DESCRIPTION OF PROPOSED CHANGE NPF-10-16 AND SAFETY ANALYSIS  
AMENDMENT APPLICATION NO. 11 OPERATING LICENSE NPF-10

This is a request to revise Appendix "A" Technical Specification 4.6.2.1.b.4.

DESCRIPTION OF PROPOSED CHANGE NPF-10-23 AND SAFETY ANALYSIS  
AMENDMENT APPLICATION NO. 11 TO OPERATING LICENSE NPF-10

DESCRIPTION OF PROPOSED CHANGE NPF-10-27 AND SAFETY ANALYSIS  
AMENDMENT APPLICATION NO. 11 OPERATING LICENSE NPF-10

Figure 6.2-1  
 OFFSITE ORGANIZATION  
 SAN ONOFRE NUCLEAR GENERATING STATION - UNIT 2

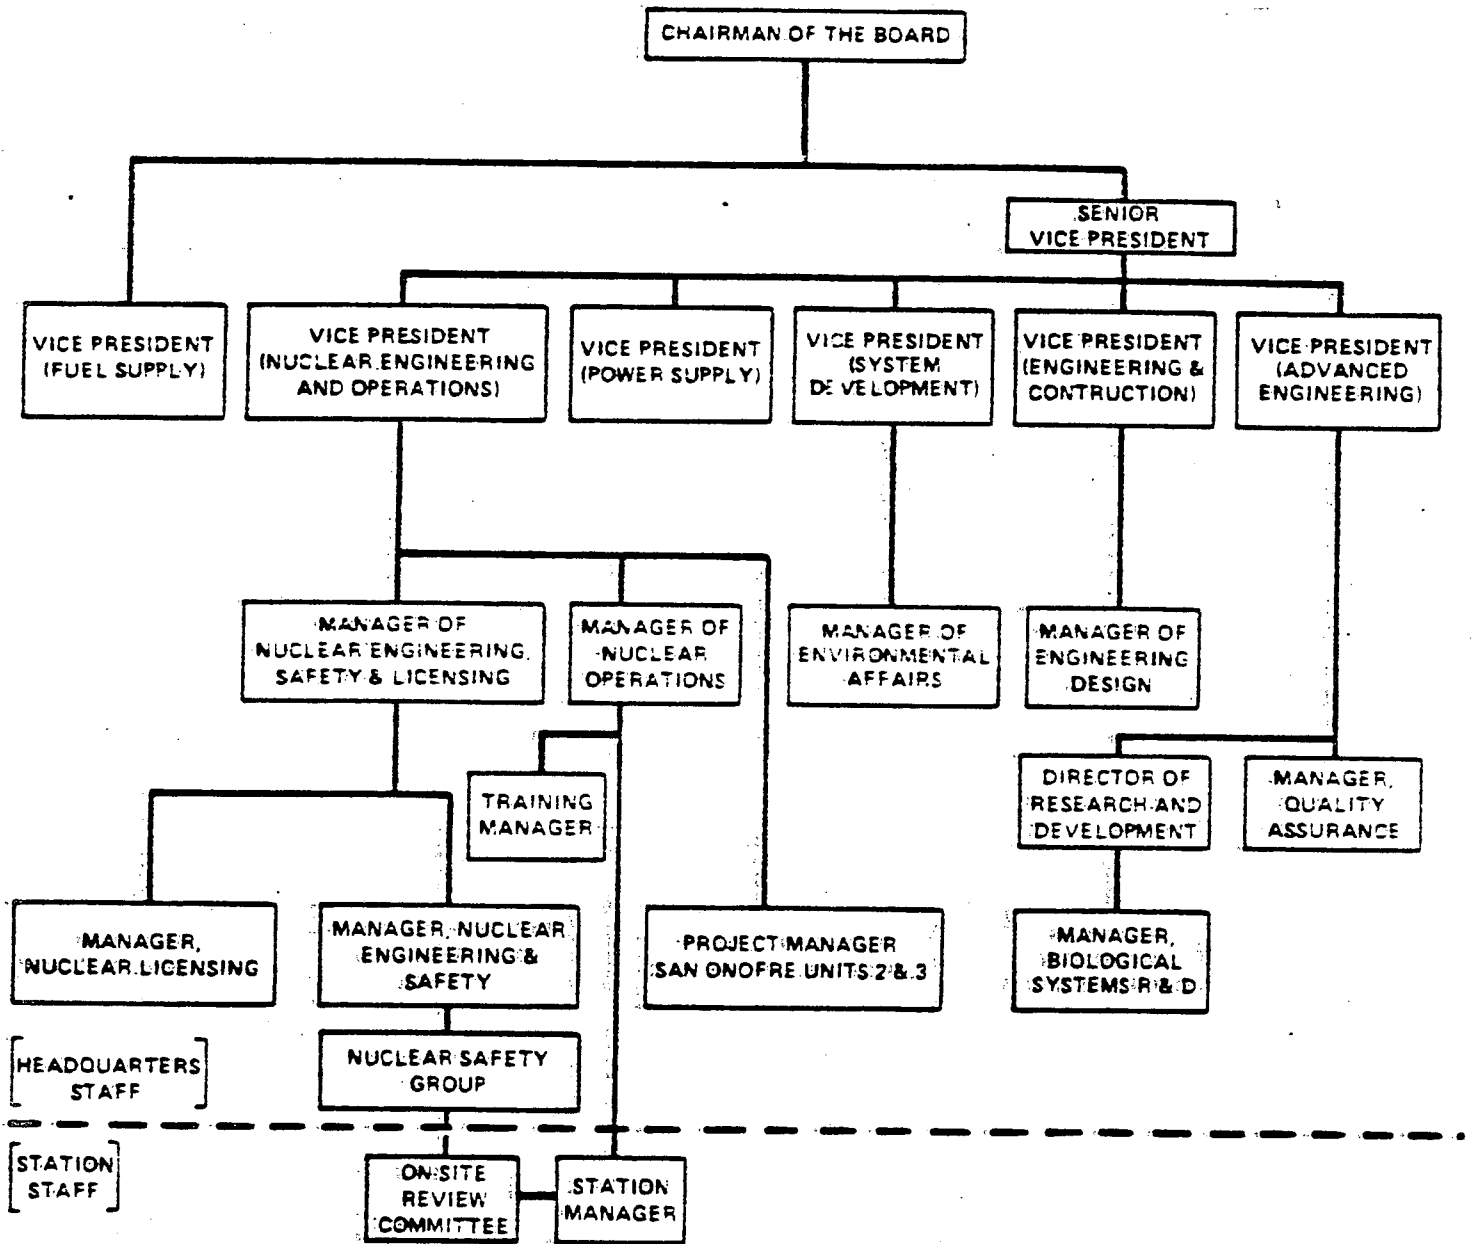
Page  
6-2 Figure 6.2-1, Offsite Organization. The word "Construction" contained in "Vice President (Engineering and Construction" is misspelled as "Contruction."
